Addendum No. 1

RE: Contract # C204738

McDowell County (HI-0010)

I-40 FROM MILEMARKER 67 TO MILEMARKER 73 (OLD FORT MOUNTAIN).

| HI-0010 | 2A-1 |

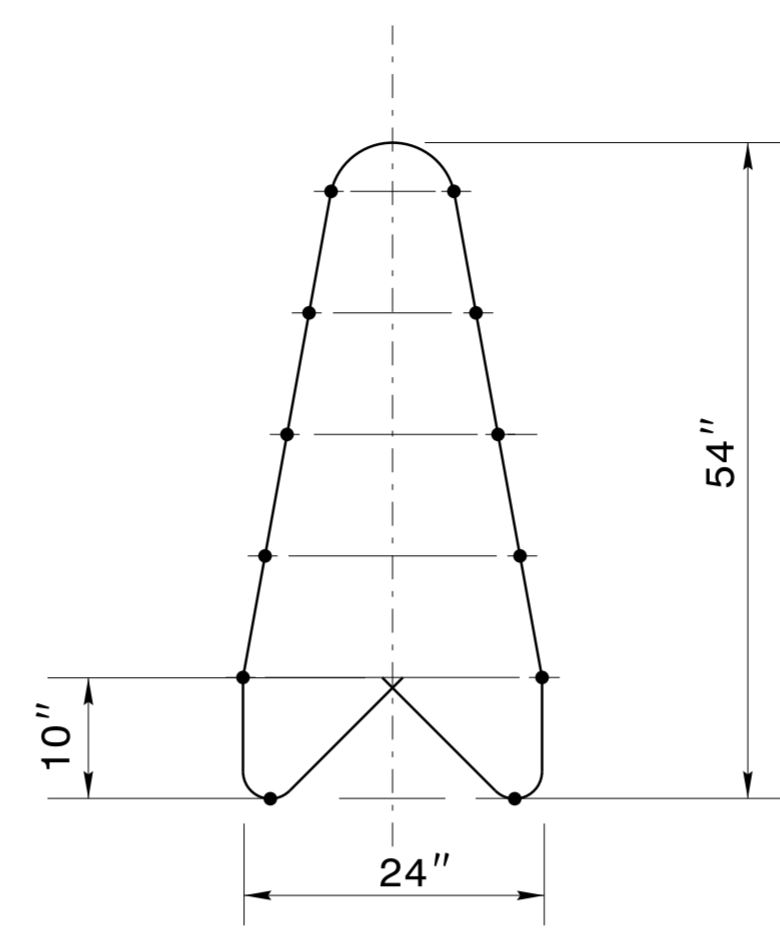
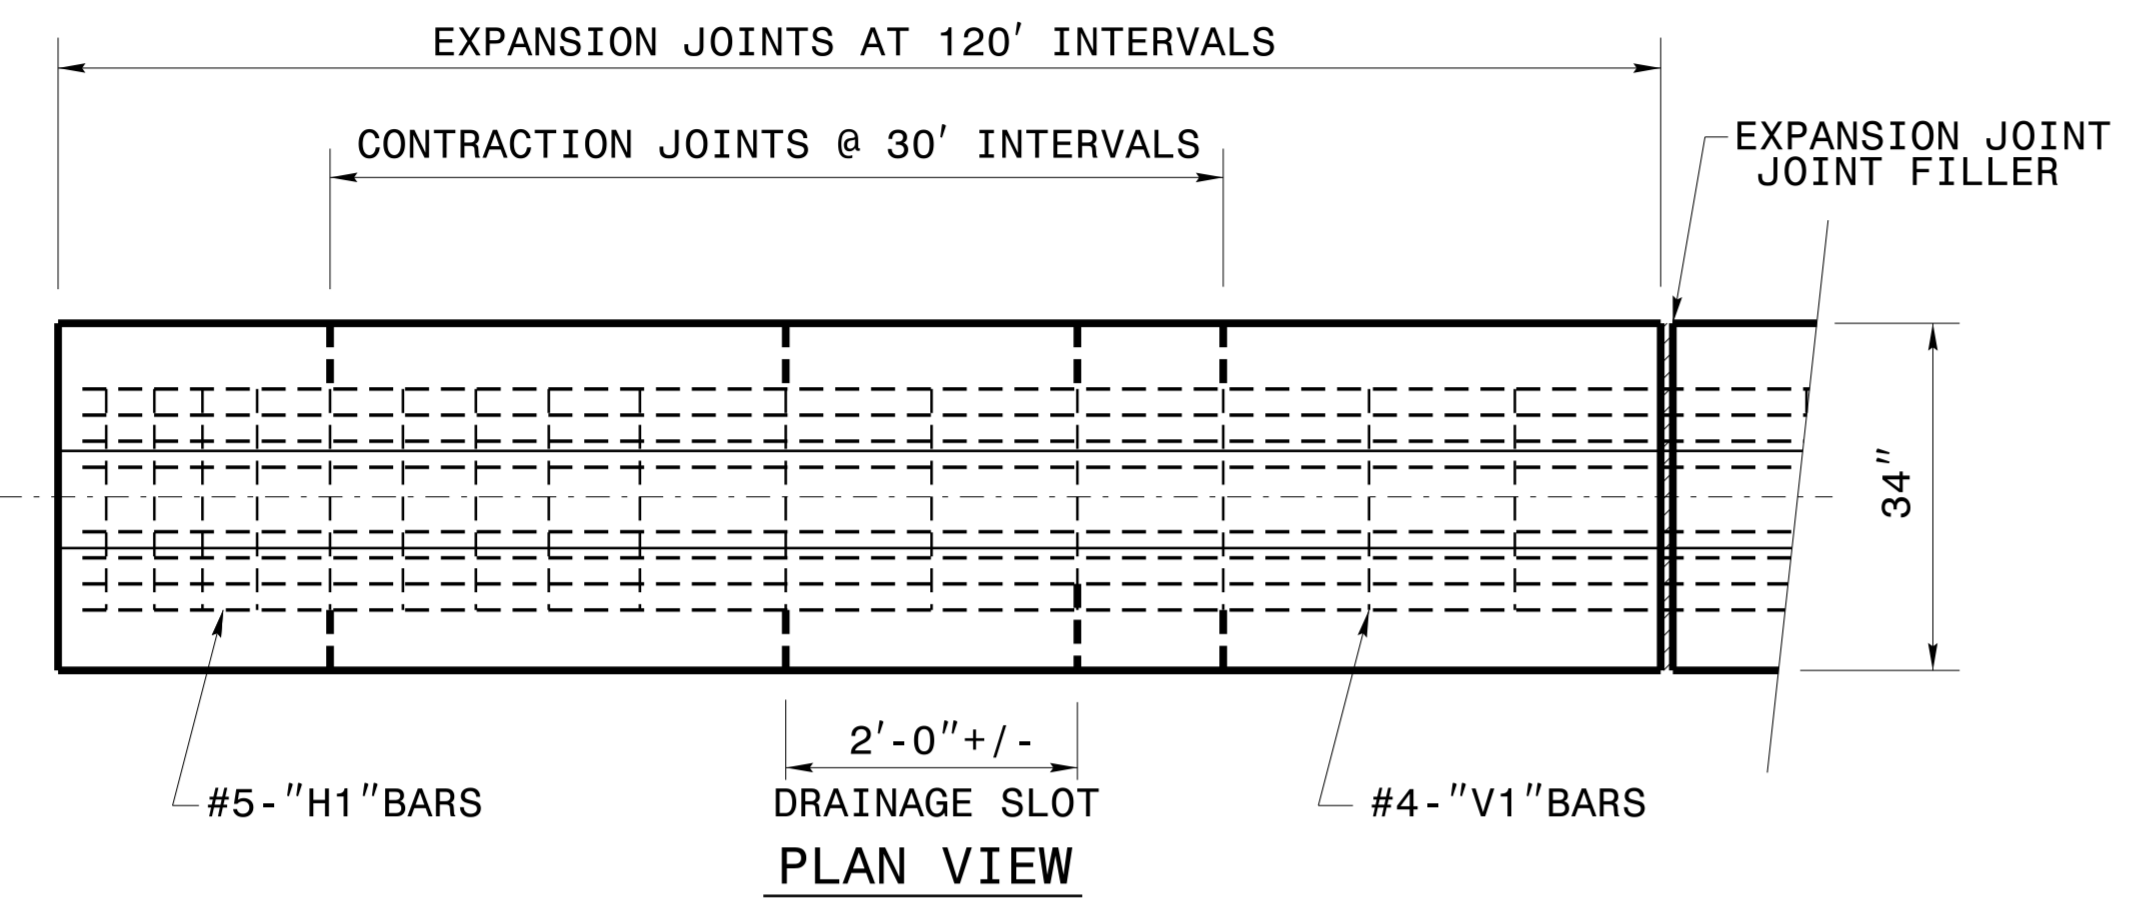
| Sheet No. | Revision |
|---------------|--|
| 2A-1 | Two notes added in lower right-hand corner. |

Remove existing portable concrete median barrier and replaced with 42" single slope concrete barrier as shown on detail sheet 2C-1 at the follow locations:
Mile Post 66.88 to 68.88, Mile Post 69.33 to 70.99 and Mile Post 71.21 to 71.72

Remove existing single slope concrete barrier and replace with 60" single slope concrete barrier as shown on detail sheet 2C-6 at the following location:
Pipe crossing between drainage structure 801 and 802 at Mile Post 68.90

**SINGLE SLOPE
CONCRETE BARRIER**

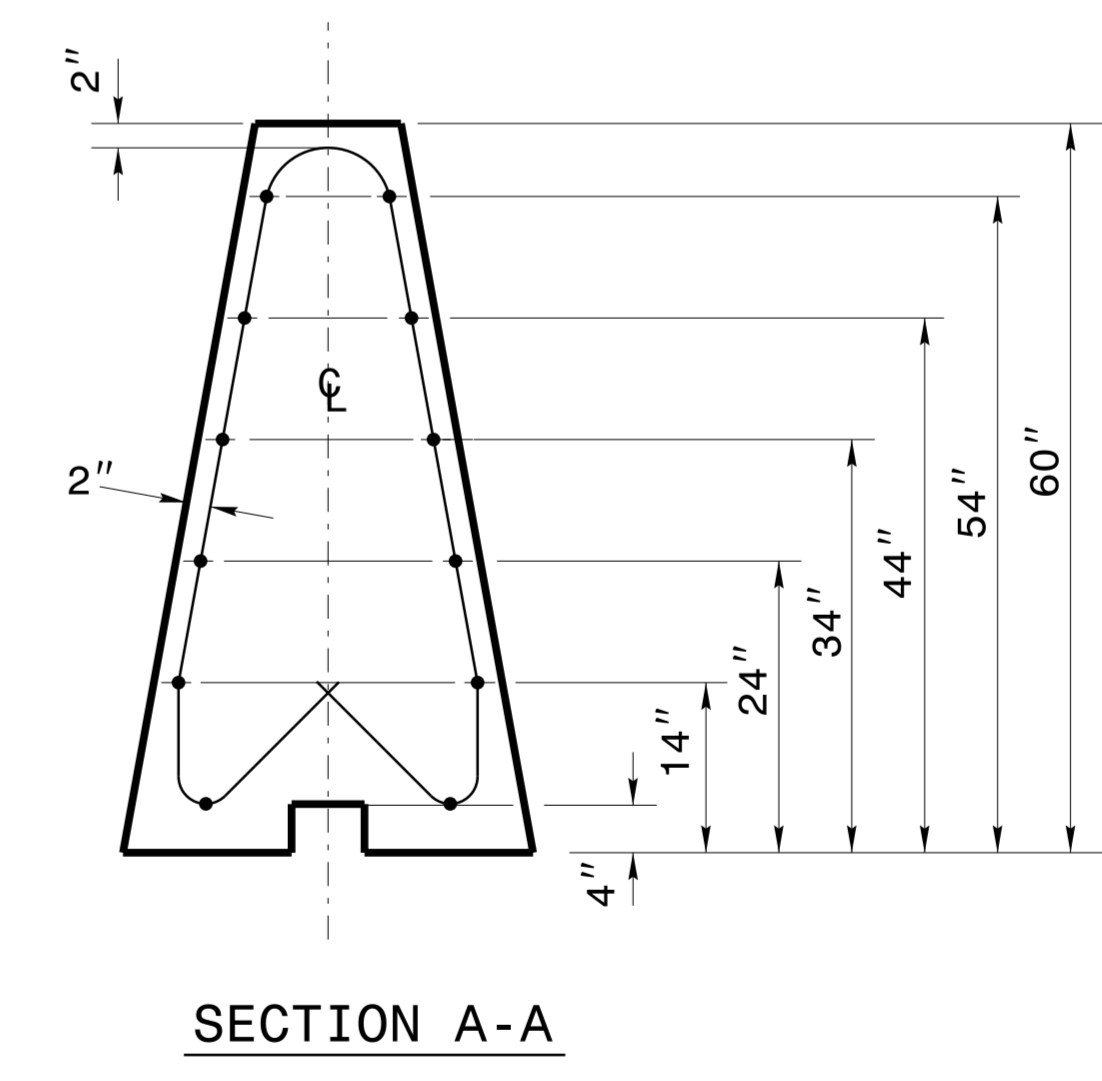
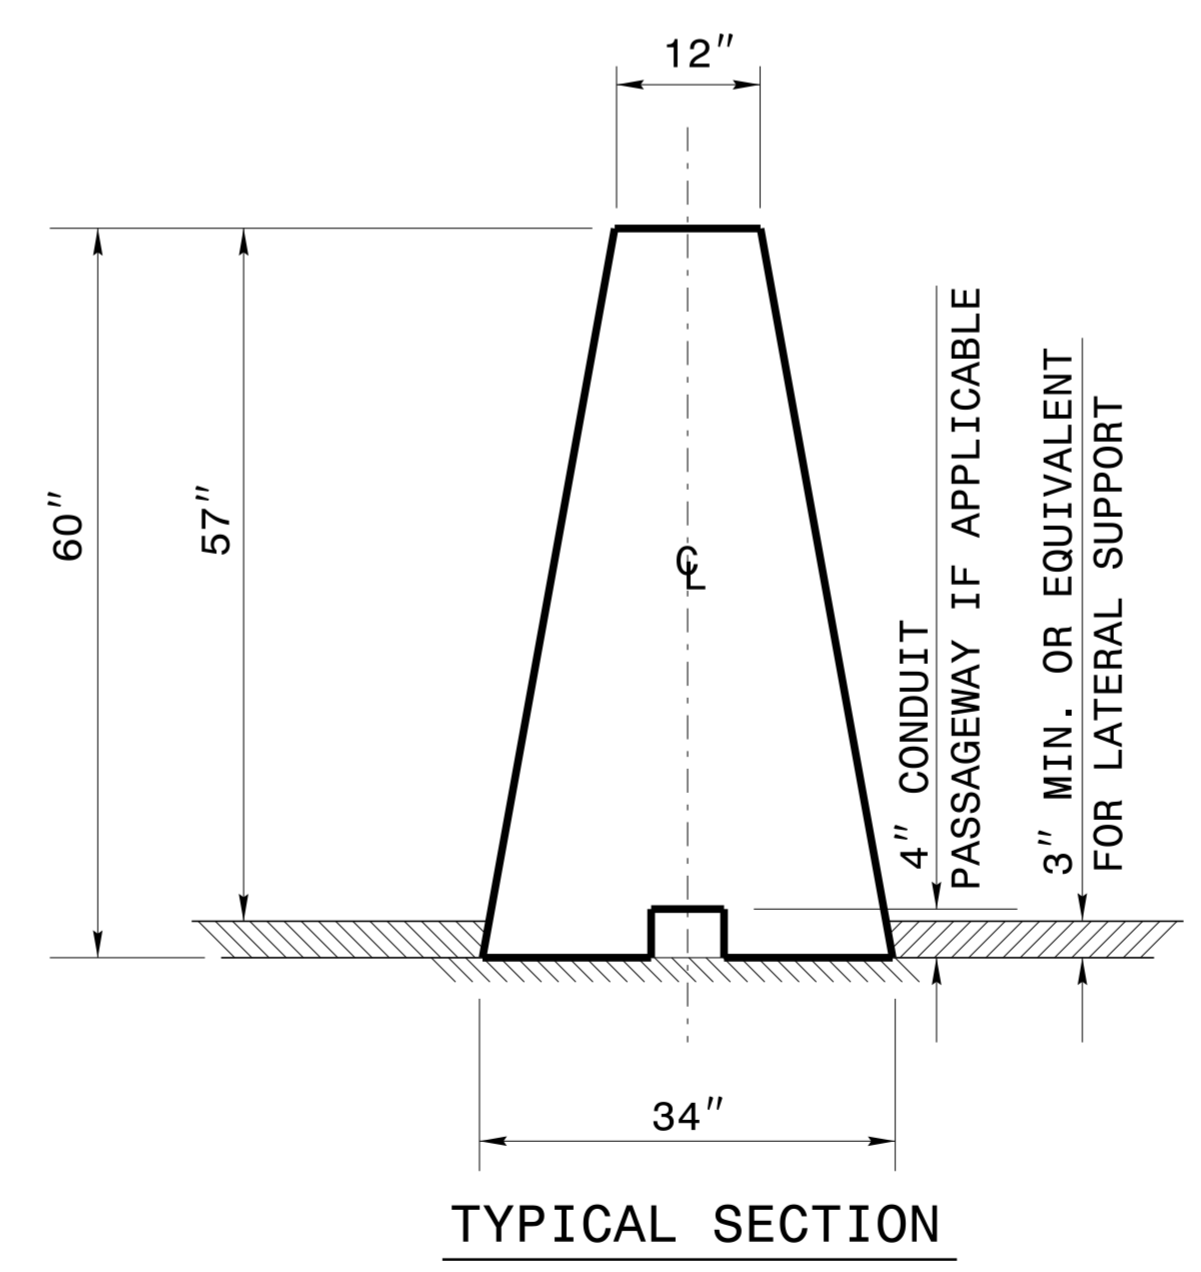
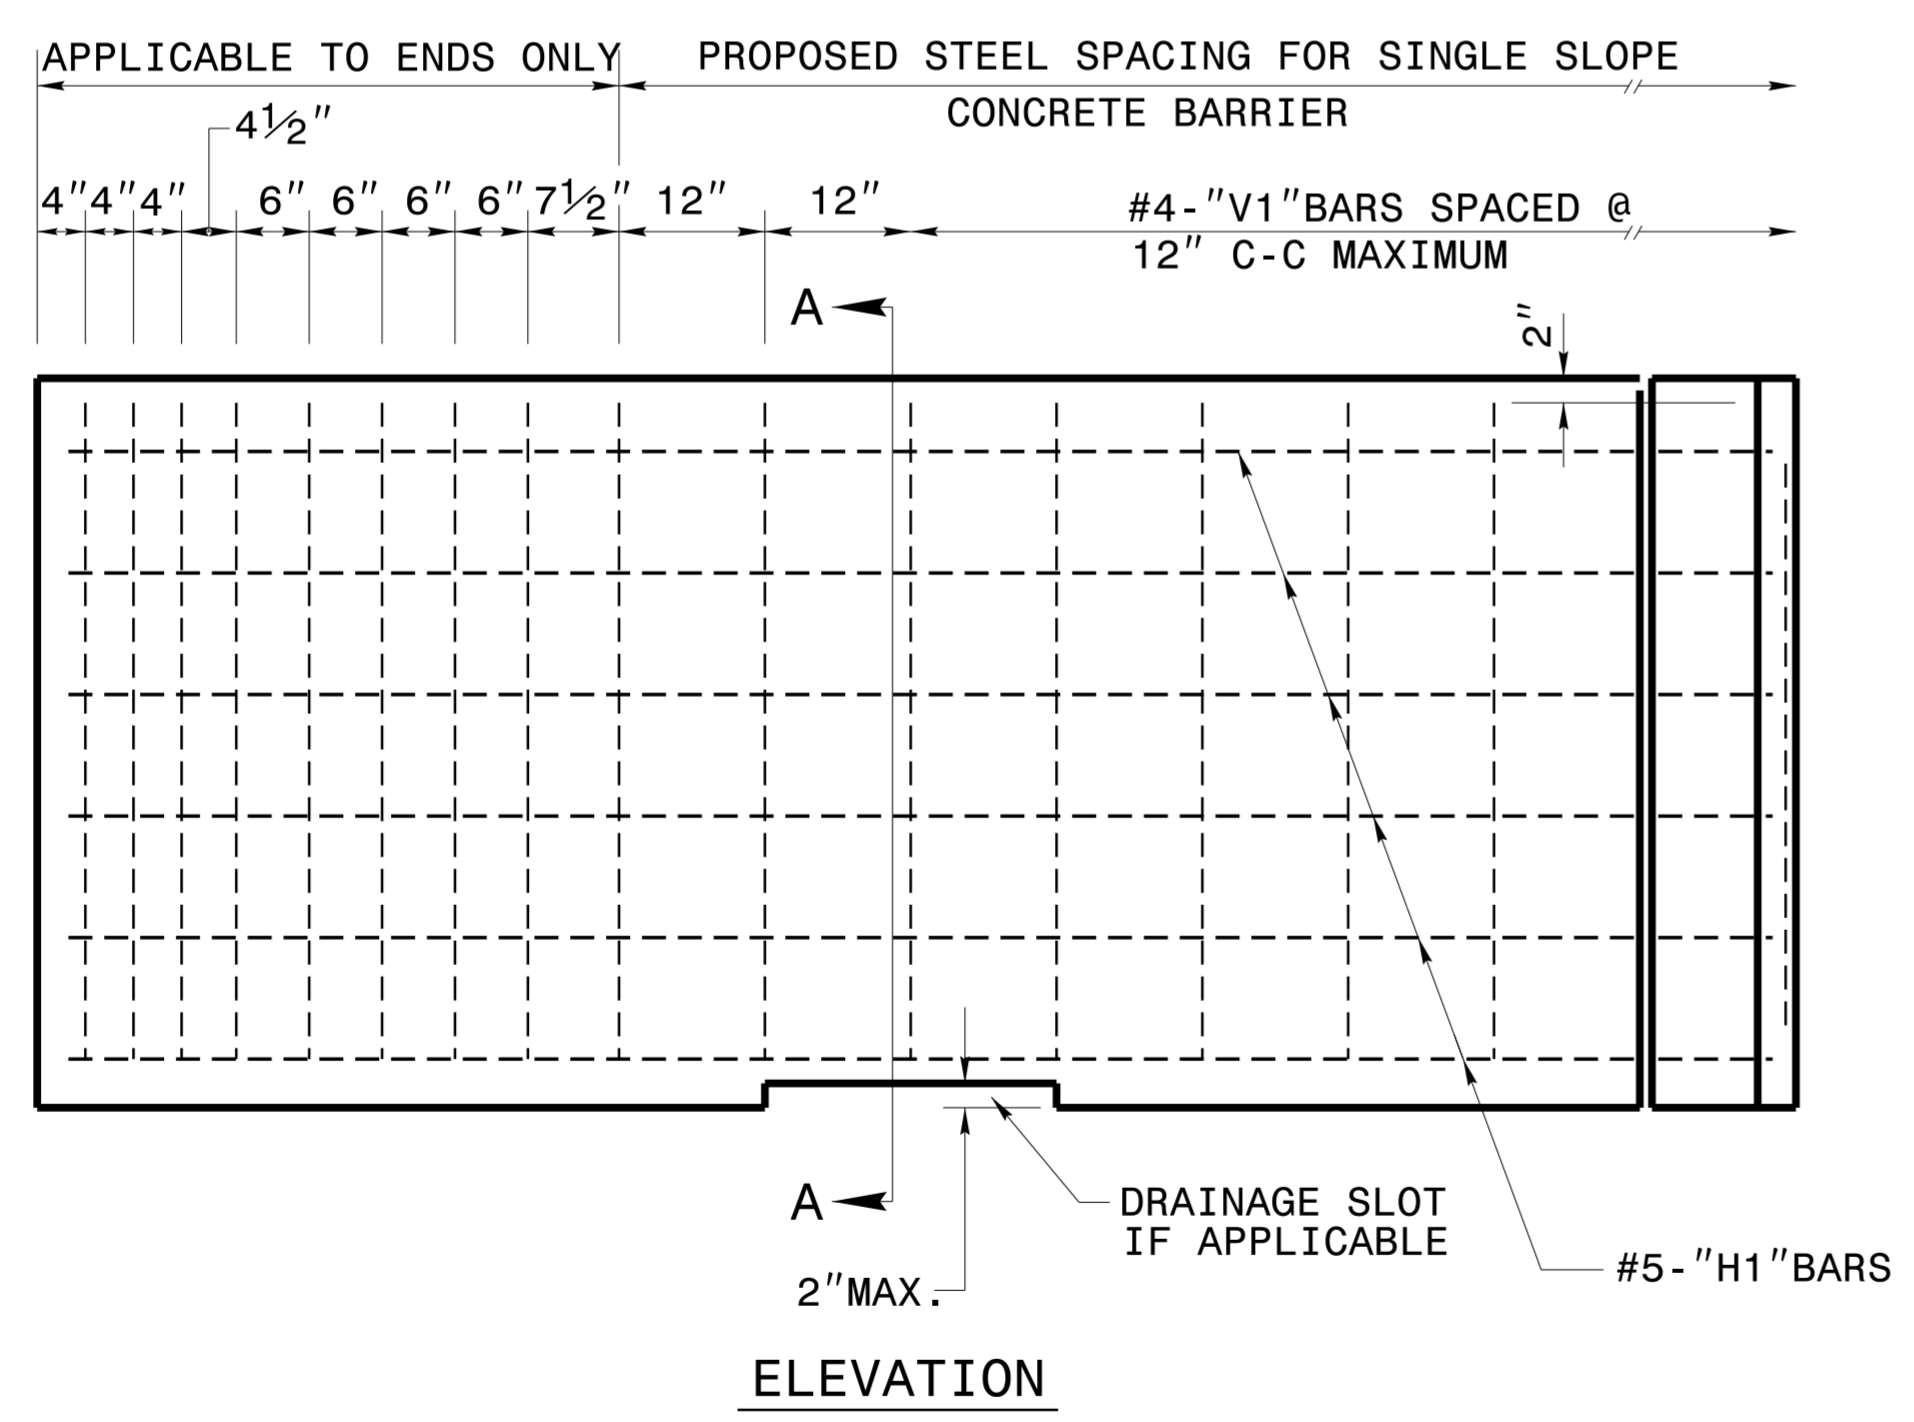
| Sheet No. | Revision |
|---------------|--|
| 2C-6 (New) | Single Slope Concrete Barrier detail plan sheet added. |
